T10/1826-D

Information technology - SCSI / ATA Translation - 2 (SAT-2)

Summary of Comments on SCSI / ATA Translation Standard

Figure 2 — ATA document structure

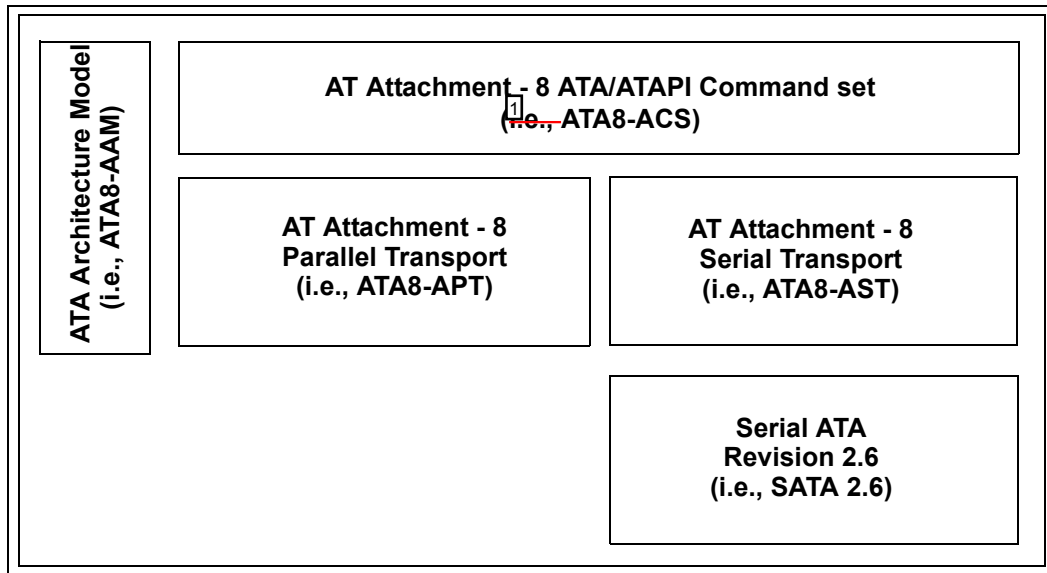
Delete all the "i.e."s from figure 2. That is not used for acronyms in parenthesis - just the acronym is fine, like "(ATA8-ACS)"

Figure 3 — SCSI / ATA Translation document role

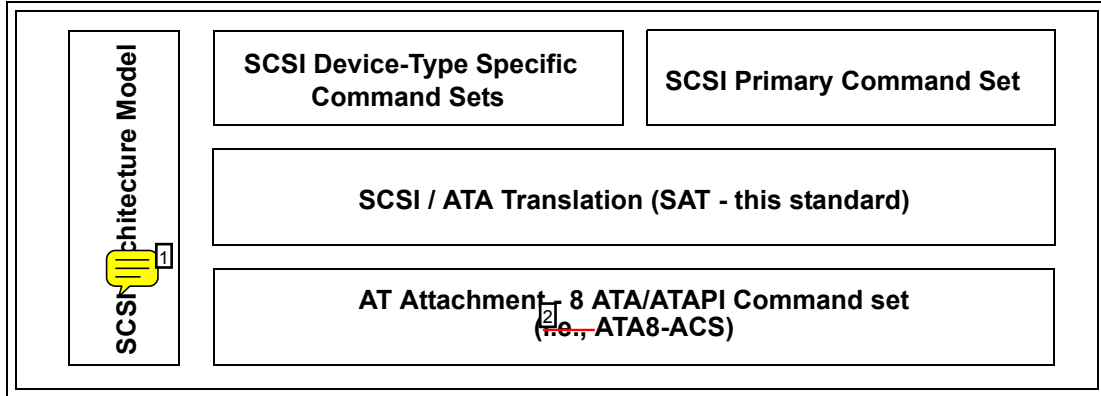
Number: 2 Author: HPQ-RElliott Subject: Cross-Out Date: 9/3/2008 9:42:24 AM -07'00'
Delete i.e., in figure 3 (see reasoning in comment on figure 2)

Figure 5 — SATL contained within a SCSI to ATA protocol bridge

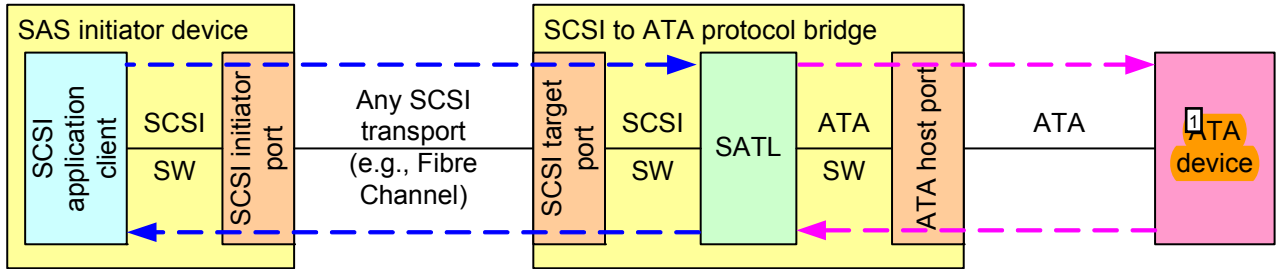
⁴~~EXAMPLE 1~~ Figure 5 shows a SATL contained within a SCSI to ATA protocol bridge, where the ⁵ATA device is being accessed by an ATA host port, and the SATL is being accessed with a SCSI target port using a SCSI transport protocol (~~e.g., FCP 3 over Fibre Channel~~).

Figure 10 — Translation of Logical Sector Alignment (part 3)

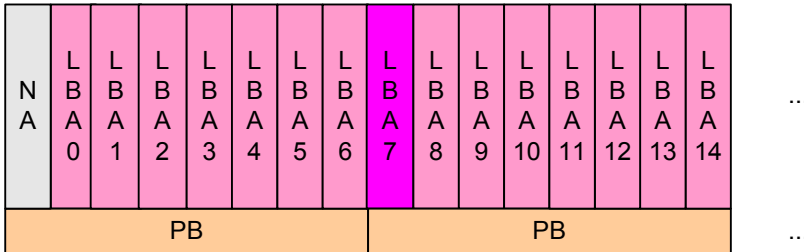
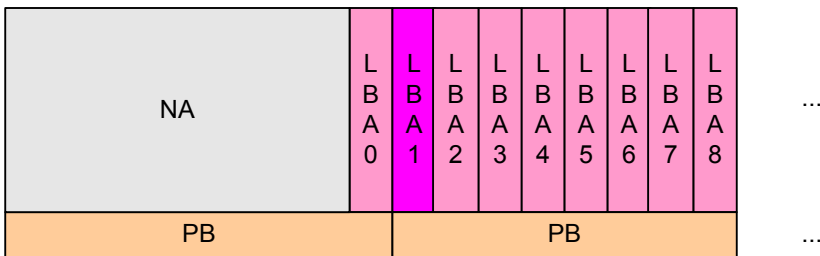
Number: 1 Author: Kevin_Marks Subject: Highlight Date: 8/11/2008 12:51:30 PM -07'00'
Figure 10 missing reference in text

Figure 9 — ³identification descriptors included by a SATL in an ATA host

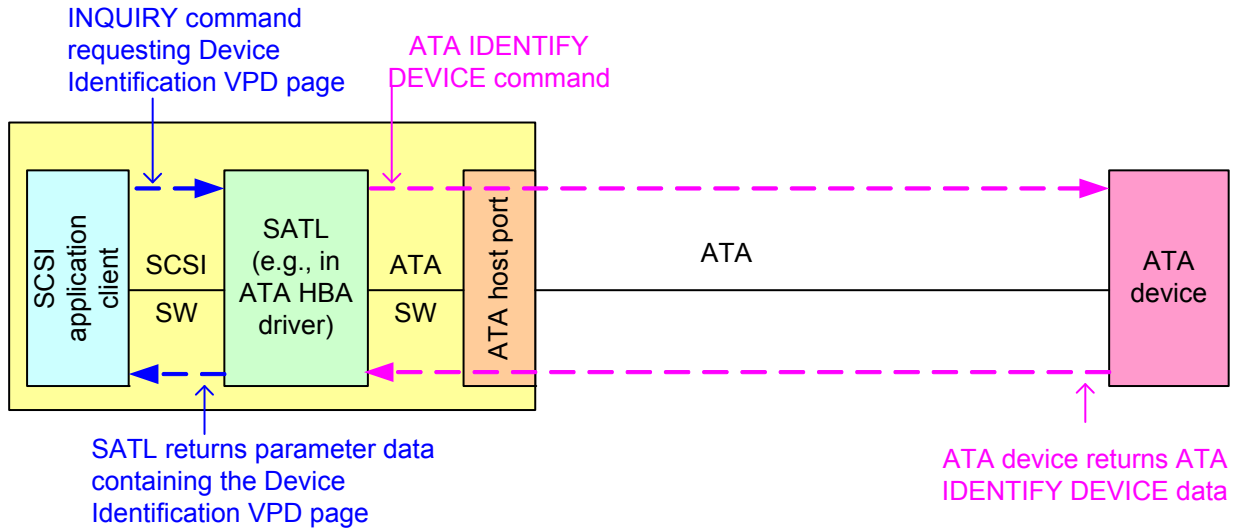
T Number: 1 Author: Kevin_Marks Subject: Highlight Date: 8/27/2008 11:35:19 AM -07'00'
identification
s/b
designation

Figure 11 — Identification descriptors included by a SATL in a SCSI to ATA protocol bridge

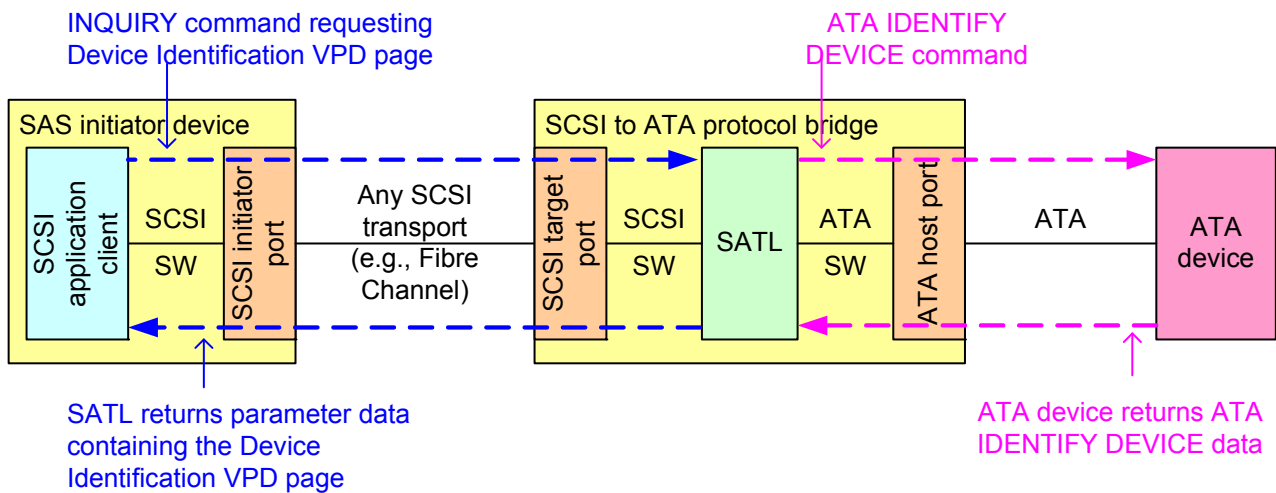
1	Number: 1 Author: HPQ-RElliott Subject: Highlight	Date: 9/3/2008 9:42:24 AM -07'00'
IDENTIFIER TYPE s/b DESIGNATOR TYPE		
Status moverby Accepted 11/3/2008 9:56:01 PM		
1	Number: 2 Author: Kevin_Marks Subject: Highlight	Date: 8/27/2008 11:41:07 AM -07'00'
IDENTIFIER s/b DESIGNATOR		
Status moverby Accepted 11/3/2008 9:55:58 PM		
1	Number: 3 Author: HPQ-RElliott Subject: Highlight	Date: 9/3/2008 9:42:24 AM -07'00'
IDENTIFIER LENGTH s/b DESIGNATOR LENGTH		
Status moverby Accepted 11/3/2008 9:56:05 PM		
1	Number: 4 Author: Kevin_Marks Subject: Highlight	Date: 8/27/2008 11:41:53 AM -07'00'
The CODE SET field is set to 1h (i.e., binary). The PIV bit is set to one. The ASSOCIATION field is set to 01b (i.e., target port). The IDENTIFIER TYPE field is set to 3h (i.e., NAA).		
This is all stated in the table. If you are going to keep this format then change text to:		
The PROTOCOL IDENTIFIER field, CODE SET field, PIV bit, ASSOCIATION field and DESIGNATOR TYPE field shall be set as shown in table 95.
